## ADDENDUM

NO. 3

**PROJECT NAME:** Johnson High School 2025 Additions and Renovations

**ADDENDUM DATE:** 15 May, 2025

3/16" = 1'-0"

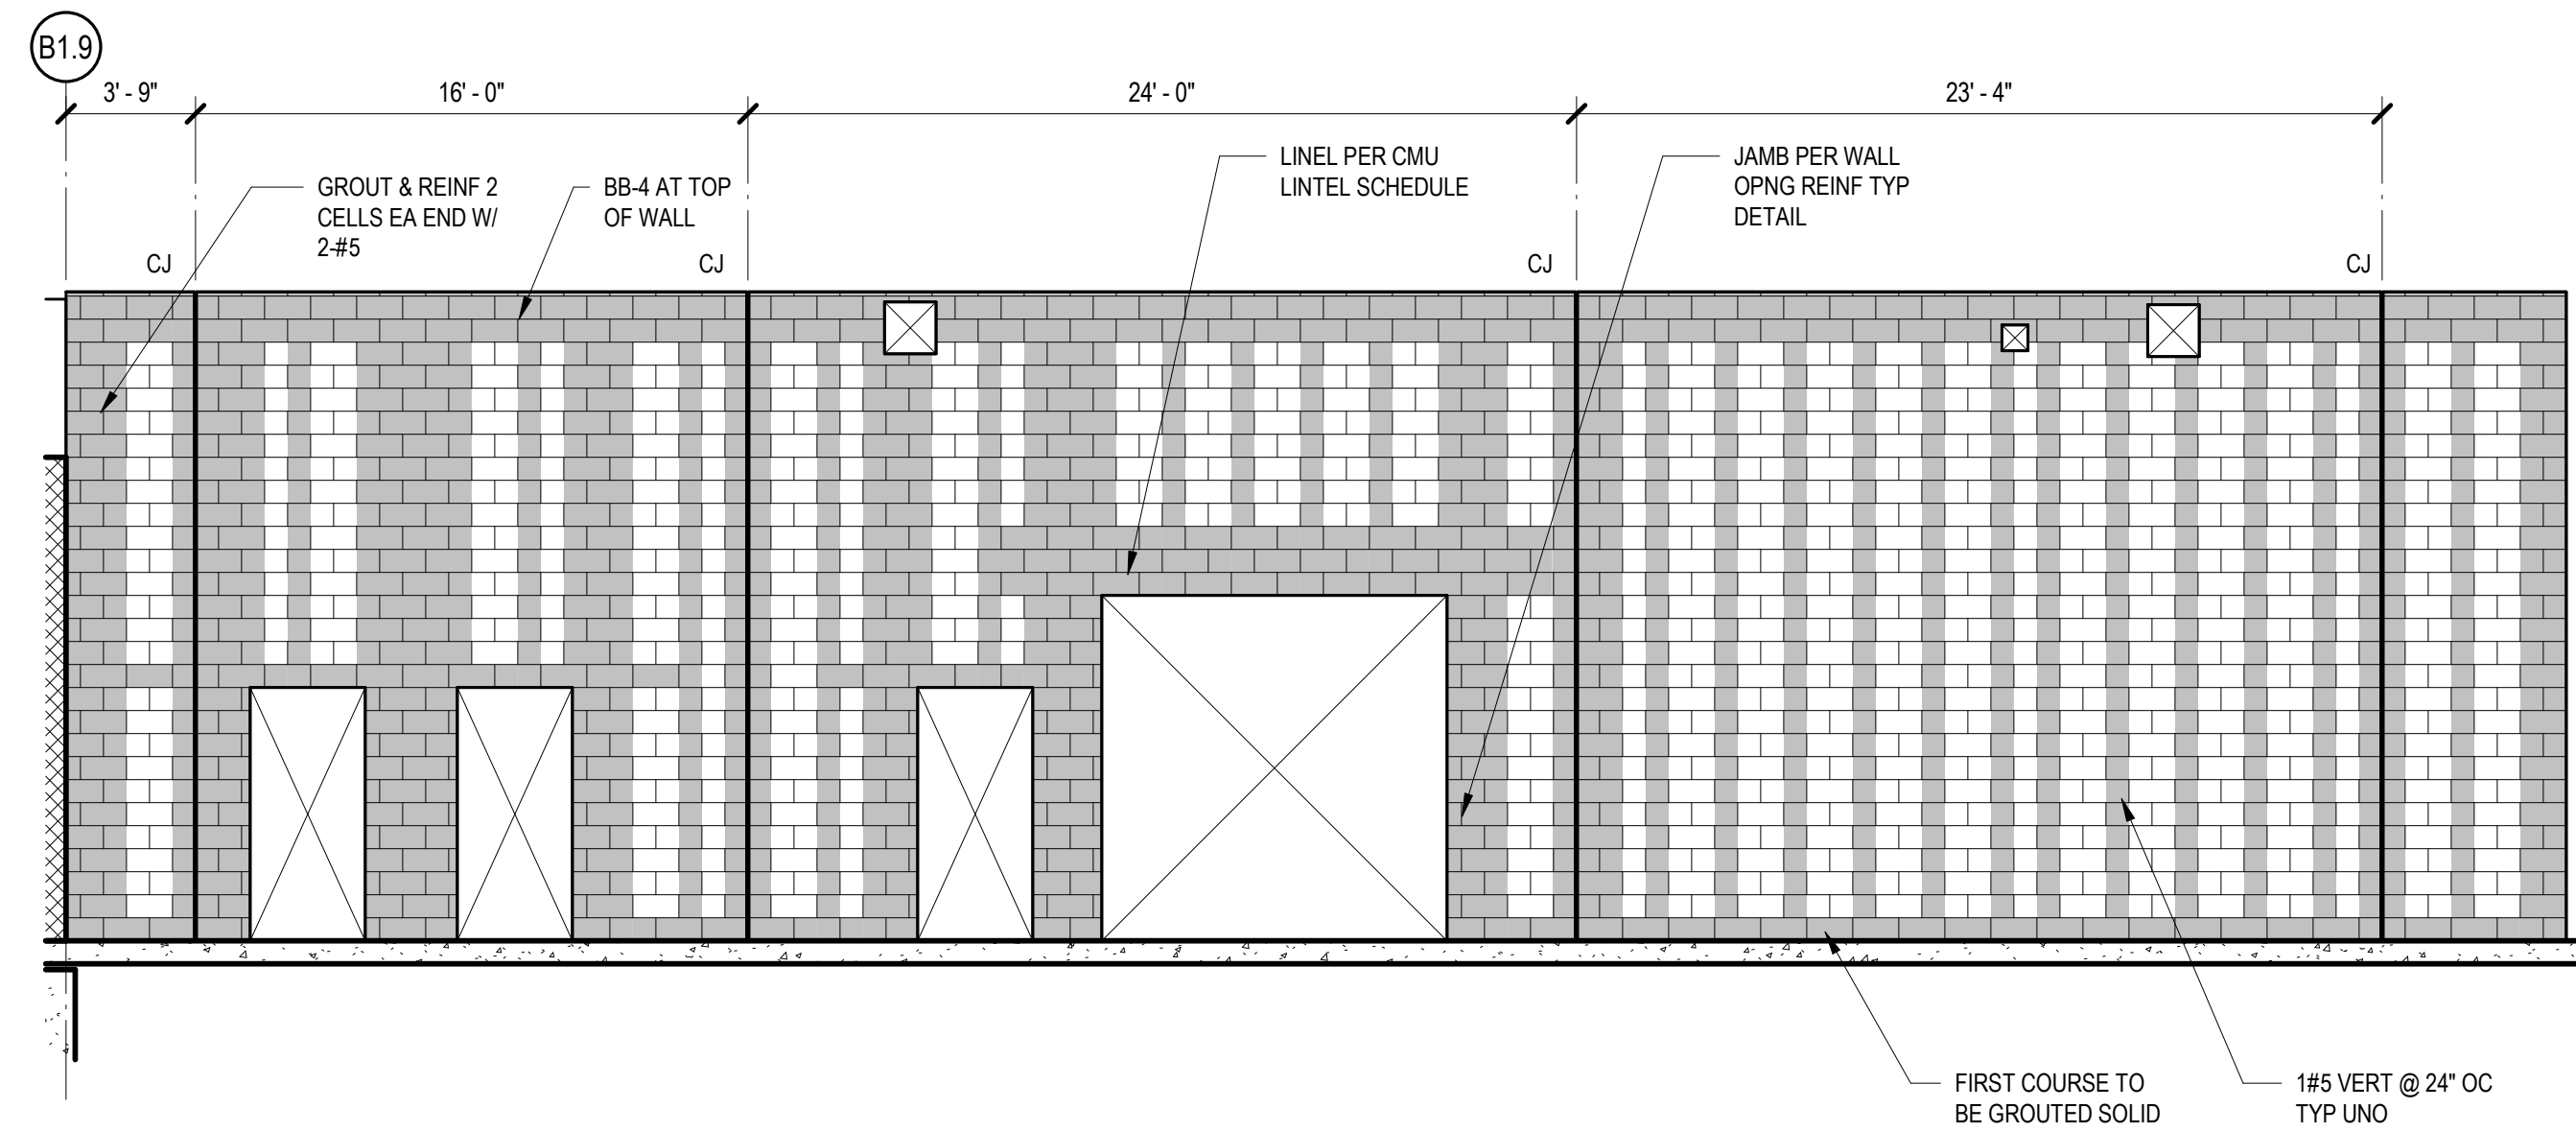
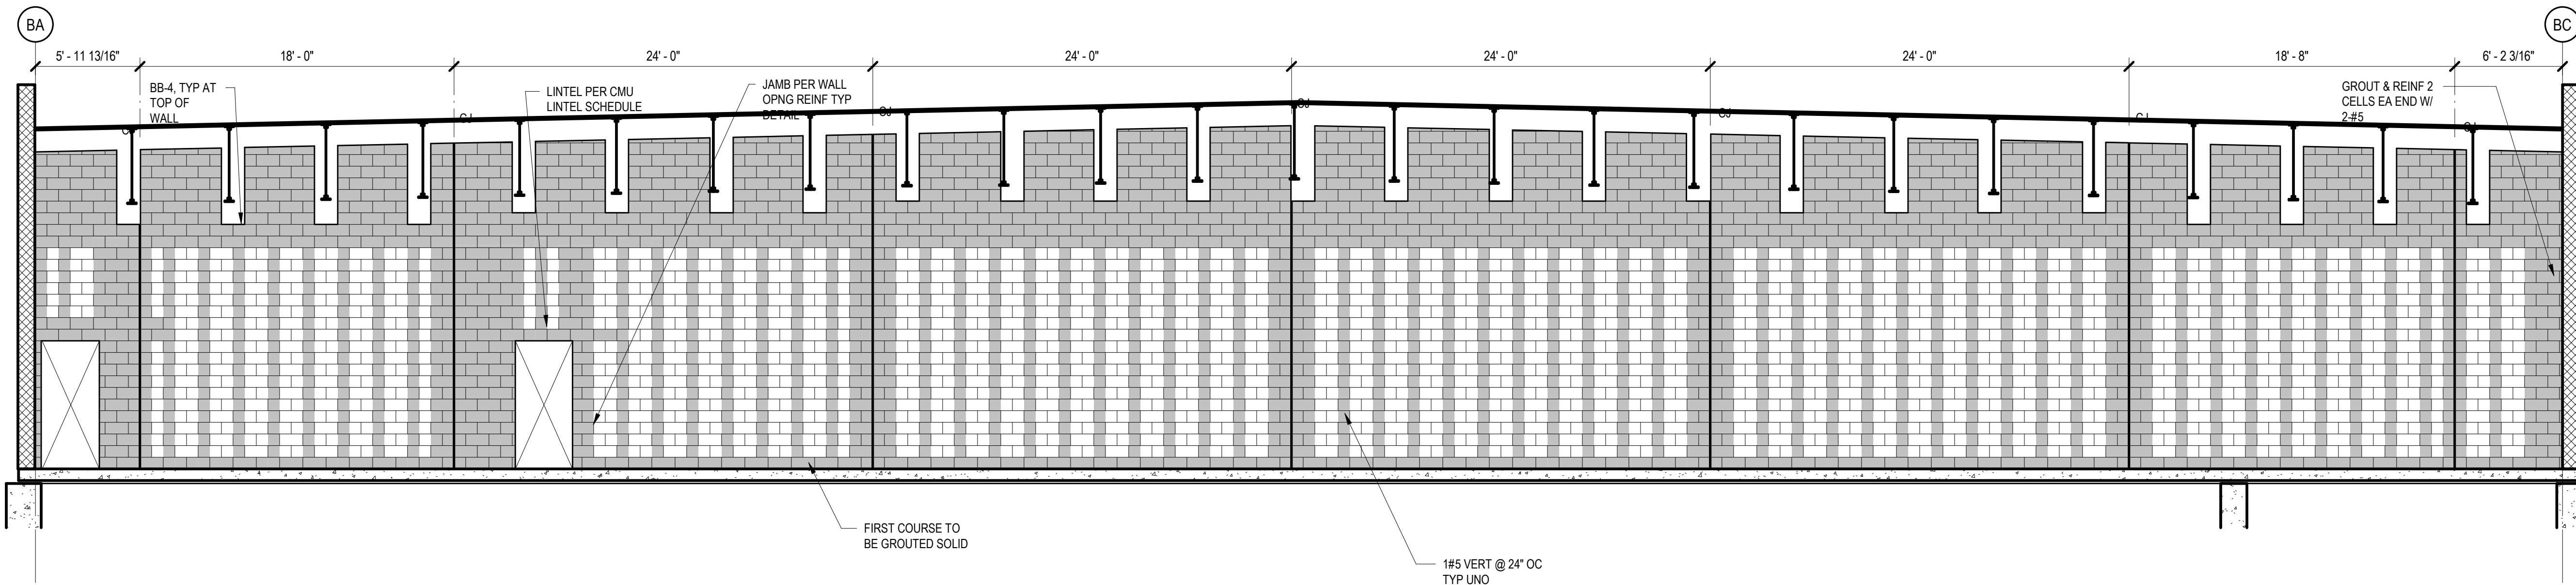
**AD No 3, Struct Item 8: To the Drawings, Sheet S4.11 "MASONRY WALL ELEVATIONS"**

- 1) Revised wall details.

### SPIRAL DUCT DETAILS

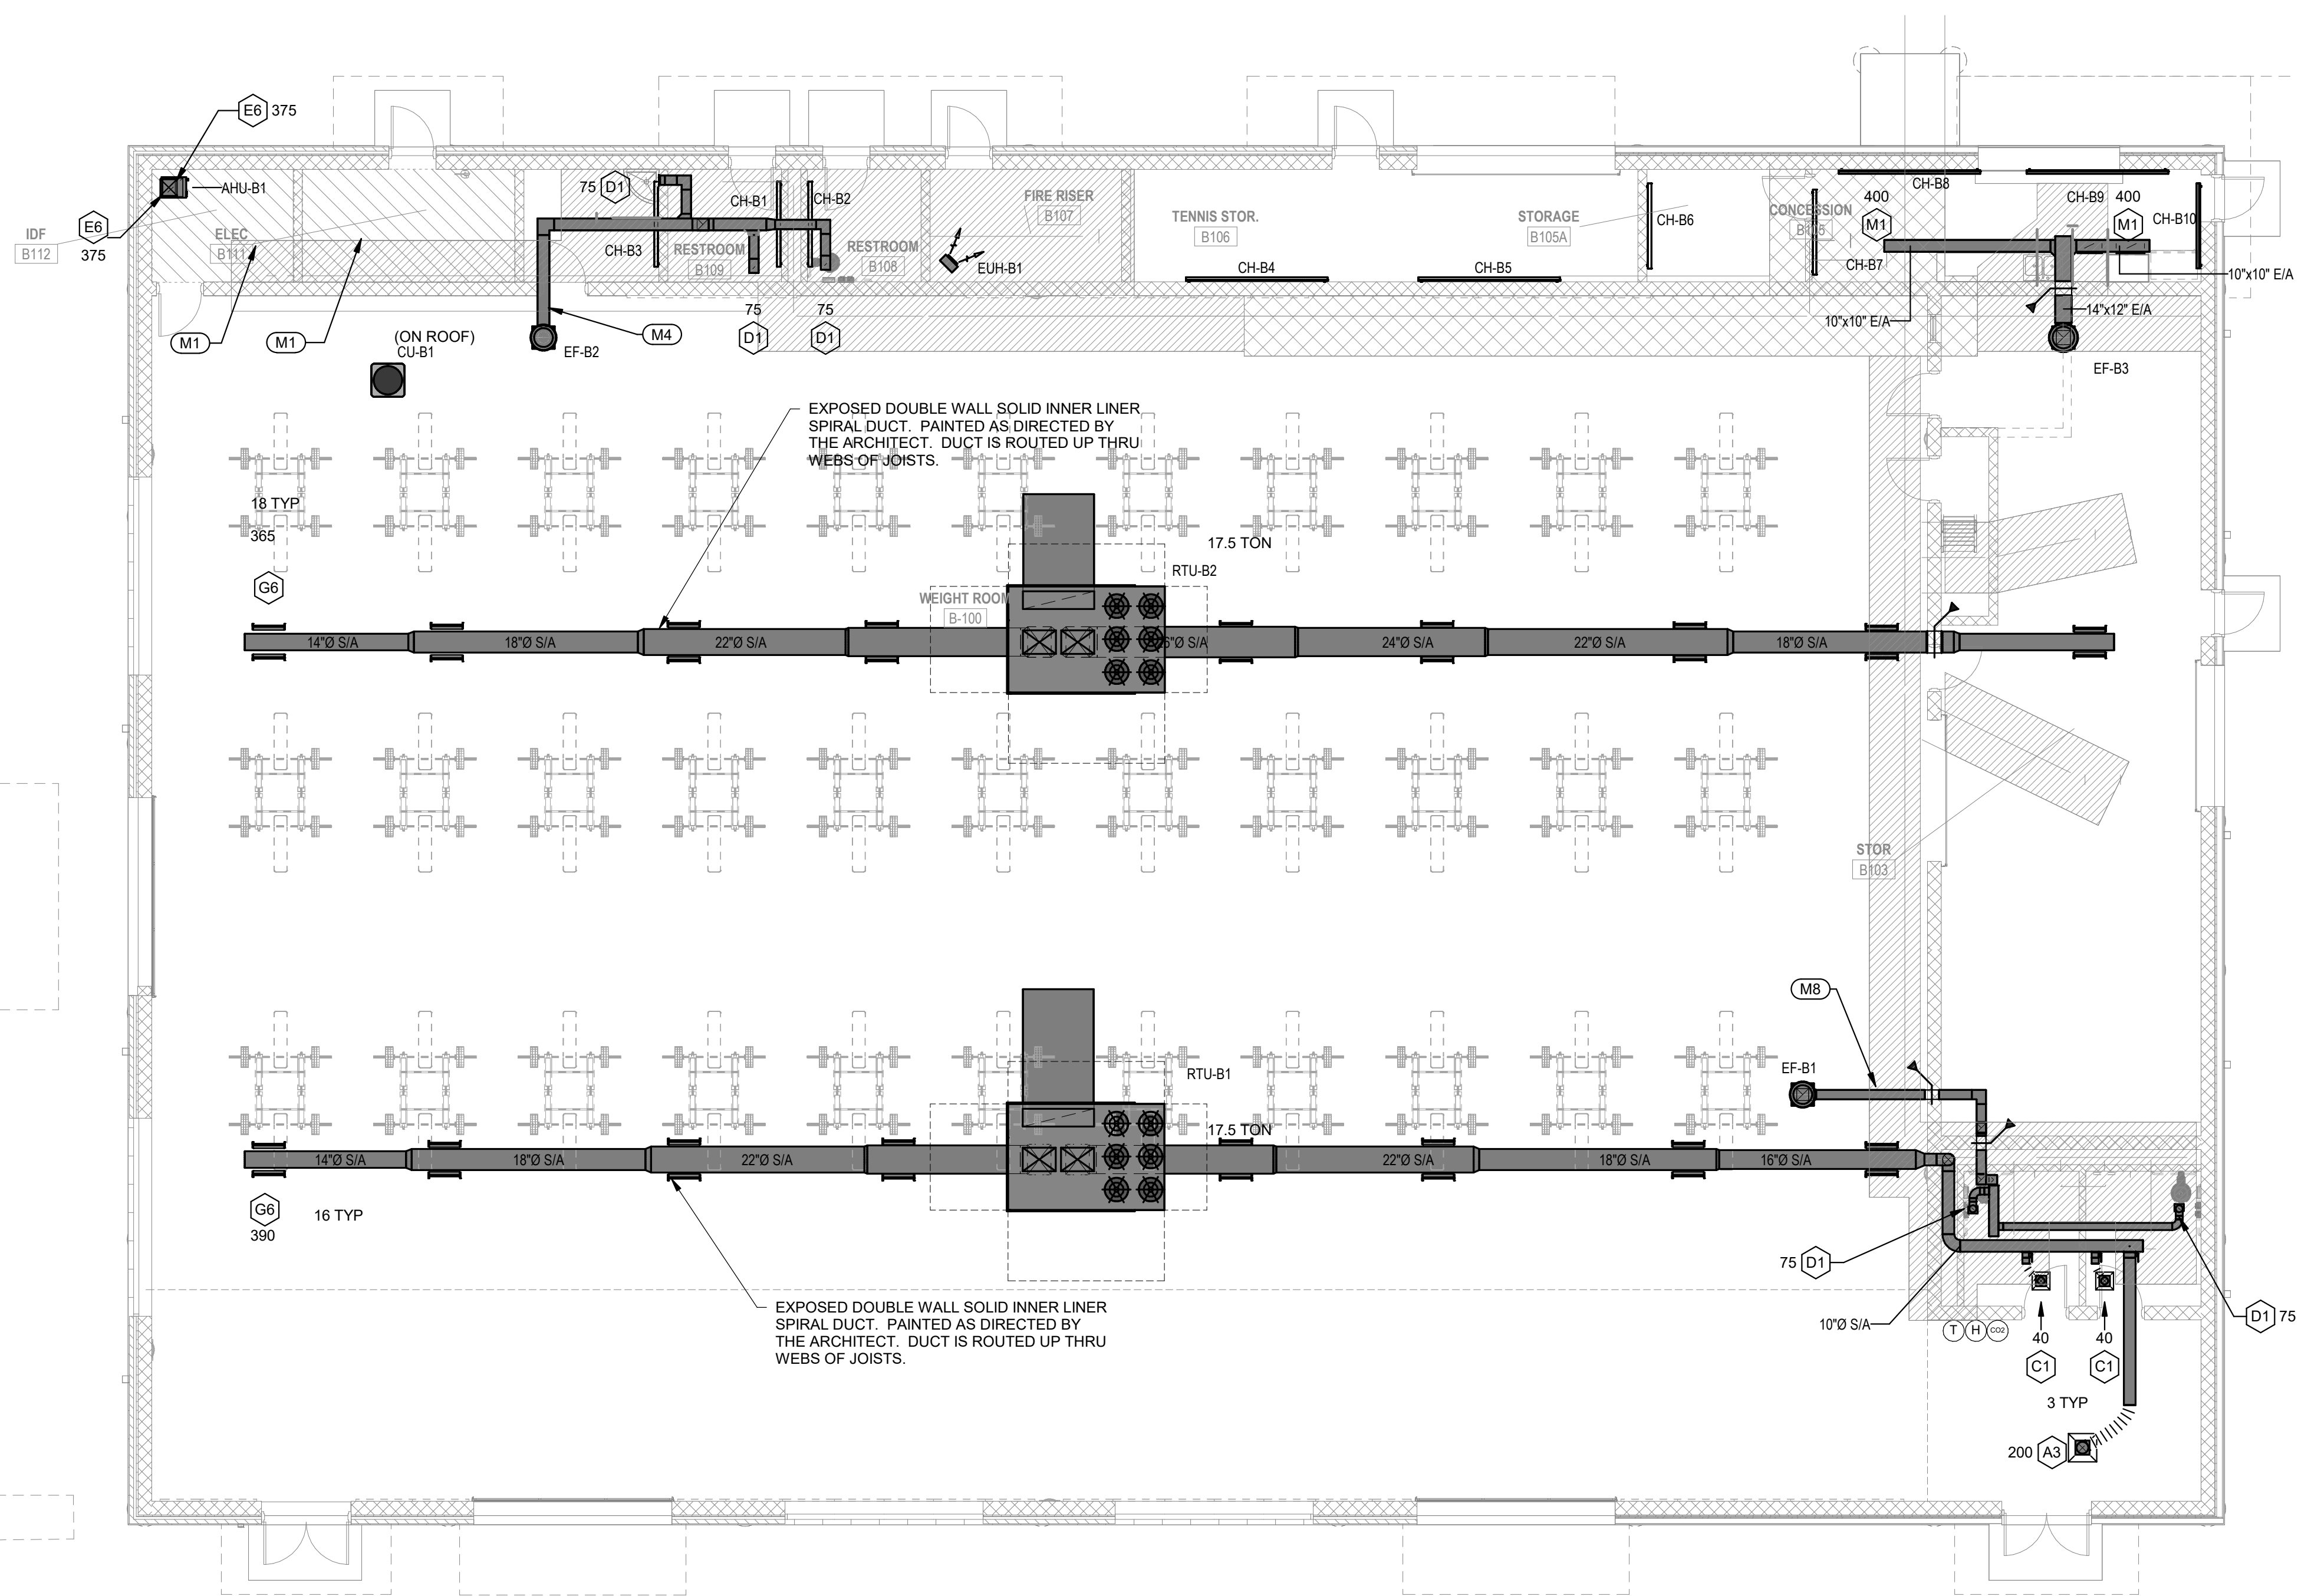
AD No 3, Mech Item 2: **To the Drawings, Sheet M2.12, "First Floor Plan - Area B - Mechanical,"**

- 2) Added spiral duct detail to sheet. Supply grilles to be set at 30° below horizontal.
